THE UNIVERSITY OF NORTH CAROLINA
AT
CHAPEL HILL

Re: Development Plan Modification No. 2 – Supplement #1

**Development Plan Modification #2
Supplement #1
May 3, 2004**

Modification #2 - Map 5 Supplement

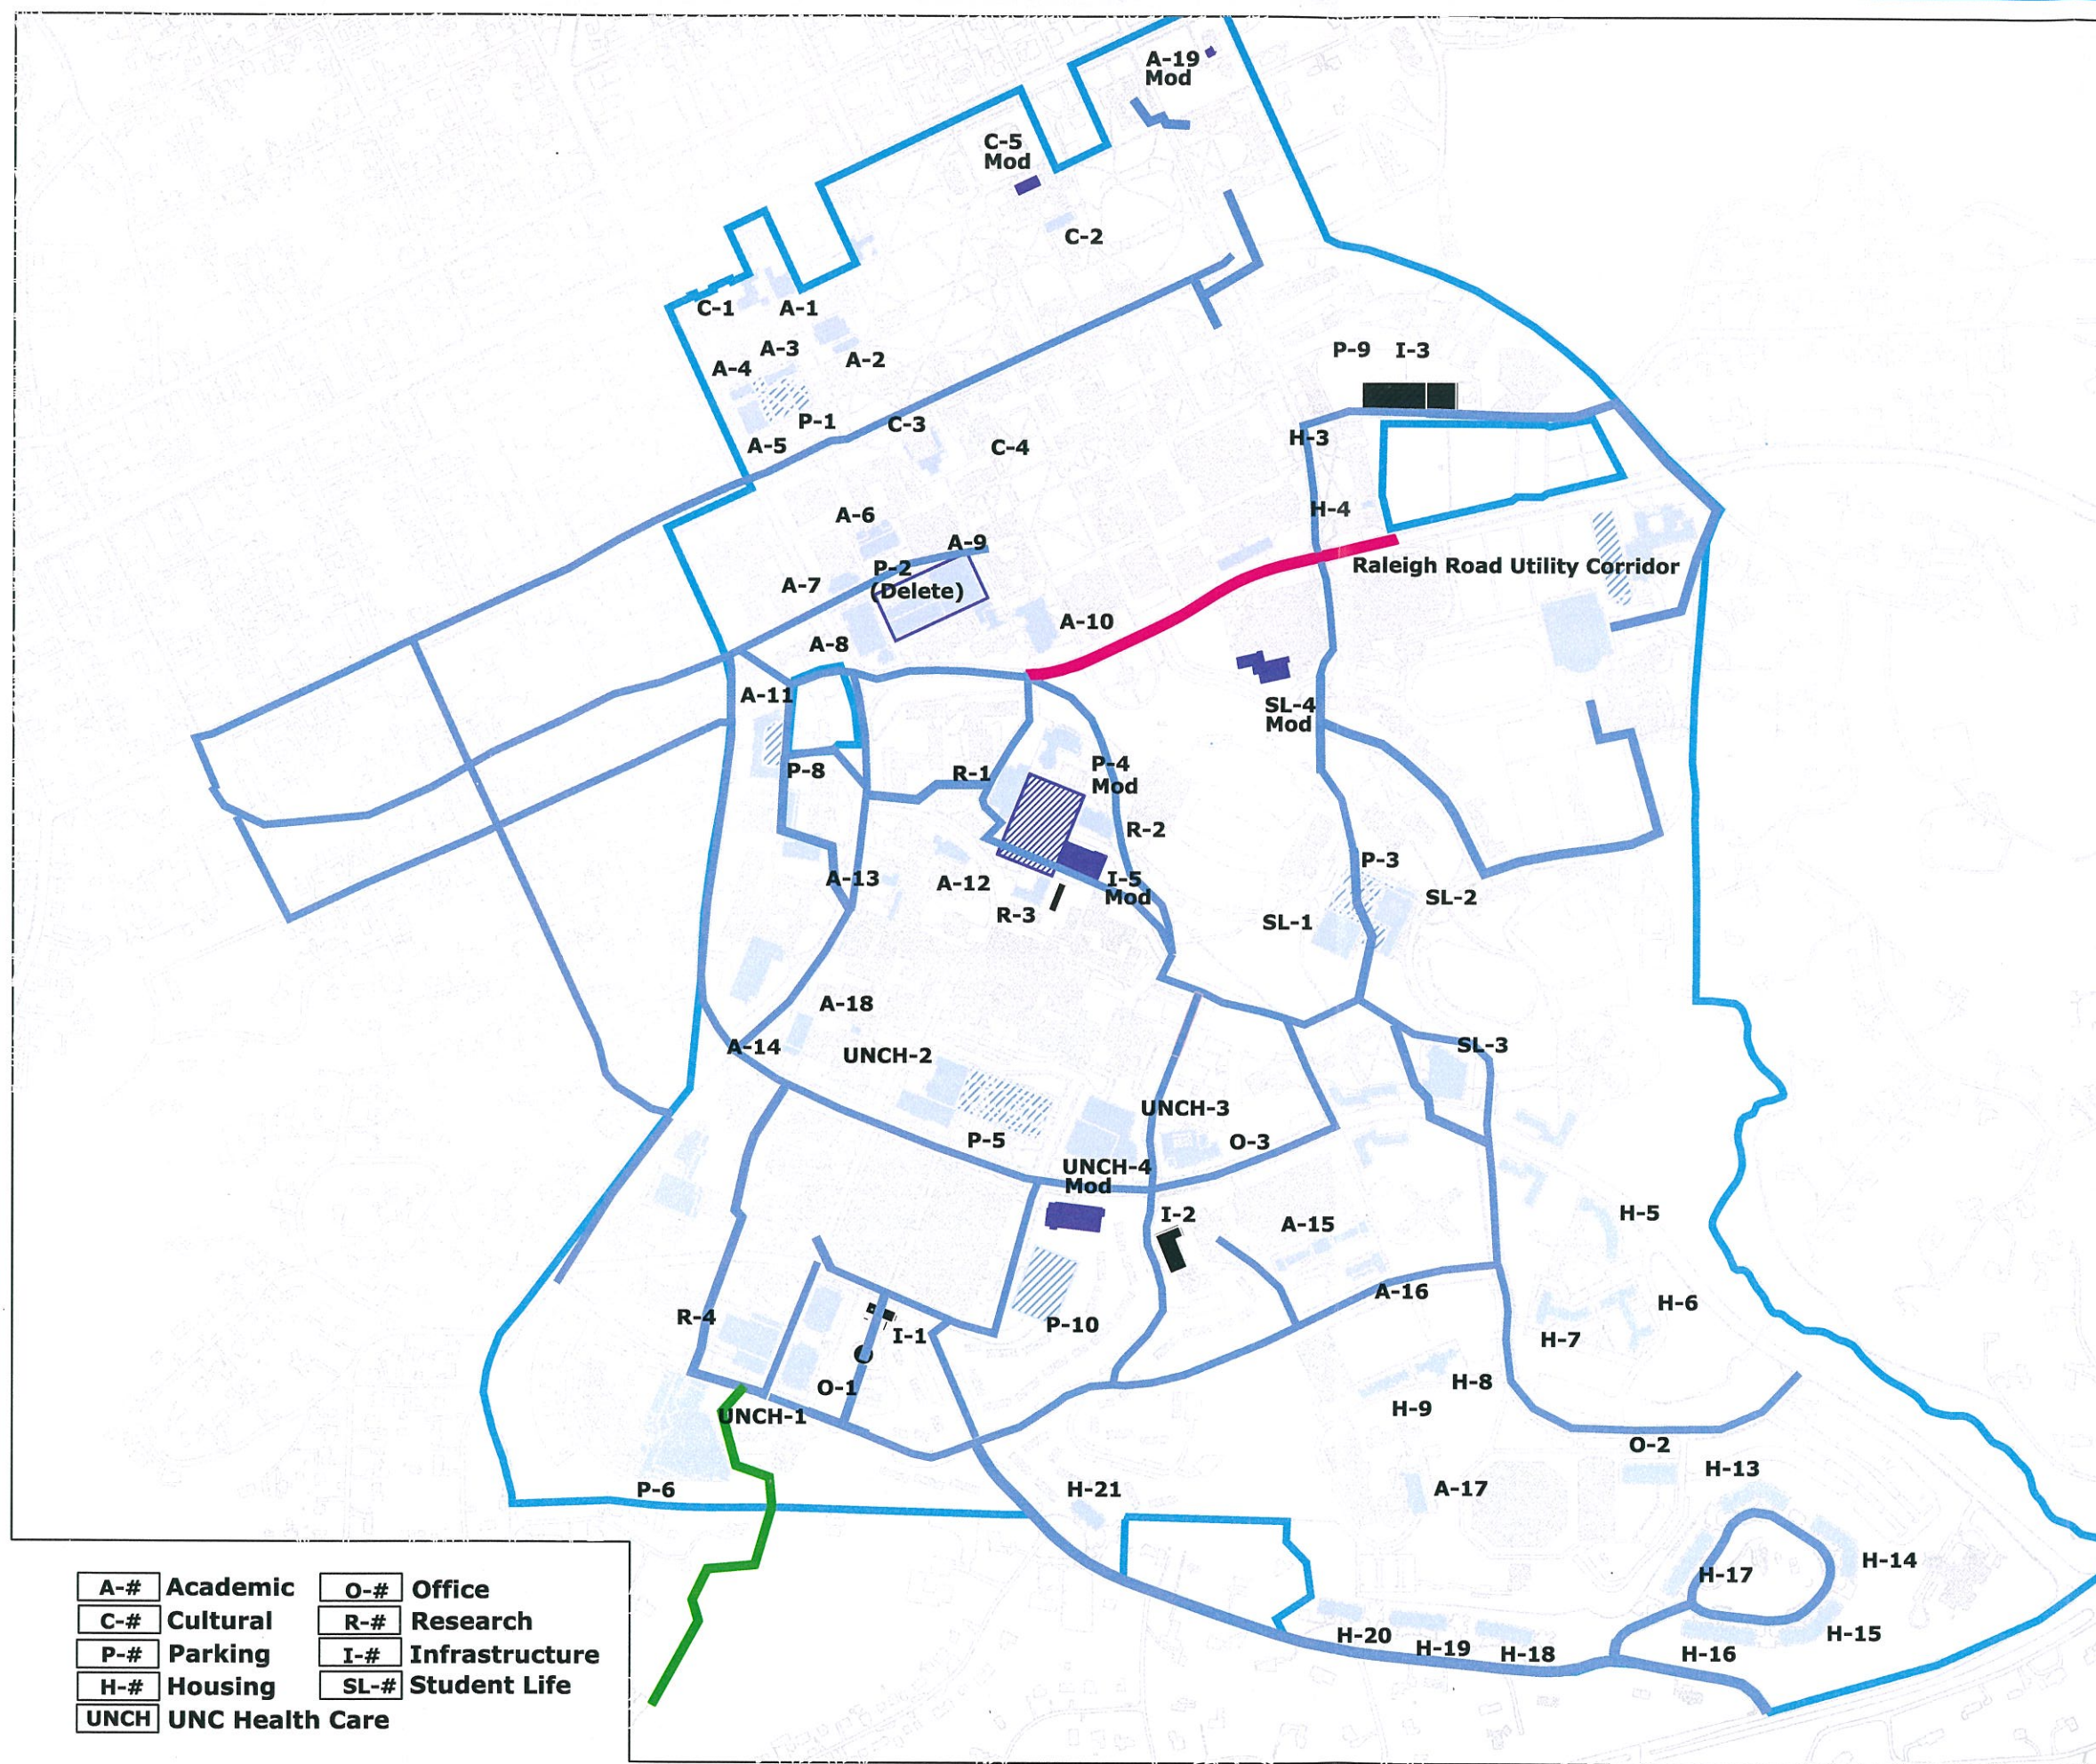
- a. Please revise Modification #2-Map 5
- i. Identify new utility corridors not proposed by previous Development Plan applications.

- ii. Remove buildings H-1, H-2.

See attached Modification #2-Map 5.

See attached Modification #2-Map 5.

Figure 1: Site Plan for 410 East Franklin Street

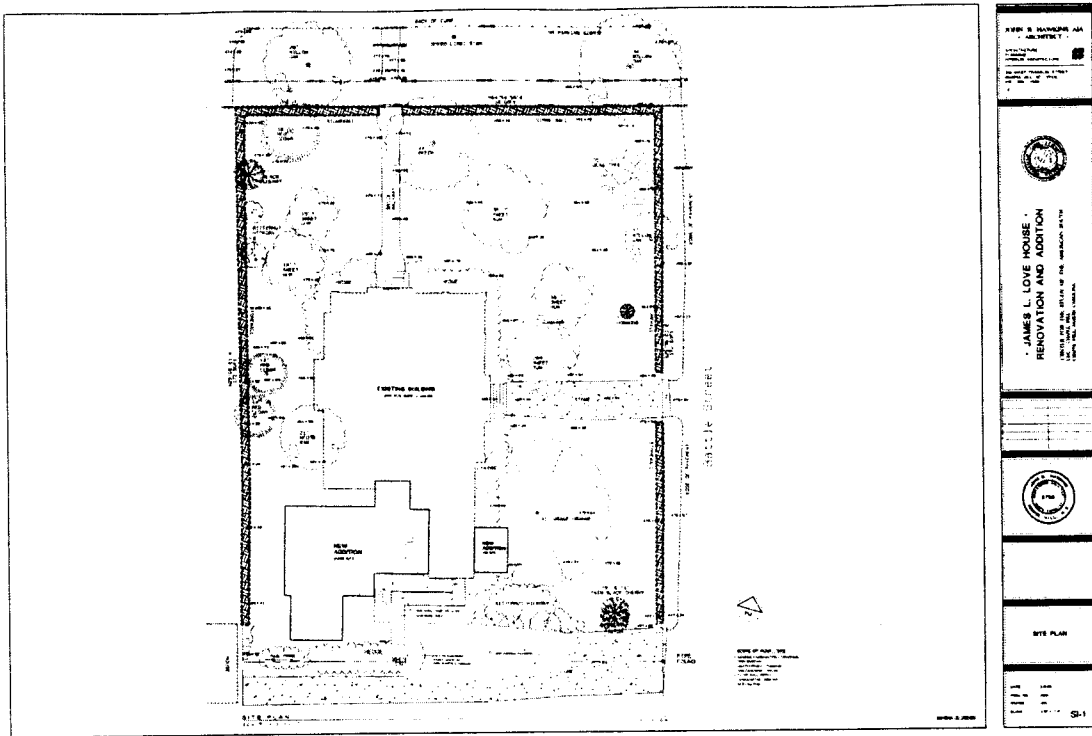
In addition to submitting this Supplement, we propose to increase the square footage for the Addition to 410 East Franklin Street (A-19 Mod.). Since submitting the Modification No. 2, we have continued the design and seek an increase in square footage from the 900 SF originally requested to 1600 SF. This increase is due to code requirements as well as a request from the Chapel Hill Preservation Society to maintain part of the existing James Love House as period rooms. We have attached additional information which includes a revised site plan and description of the changes.

In the Development Plan Modification No. 2, the proposed addition was nine hundred square feet. As design work has progressed the proposed addition has increased in size by seven hundred squared feet to a one thousand six hundred square foot addition. This increase in size is due to requests from the Preservation Society of Chapel Hill to use the front two parlors of the existing house as ceremonial reception rooms and historical display spaces as well as code requirements.
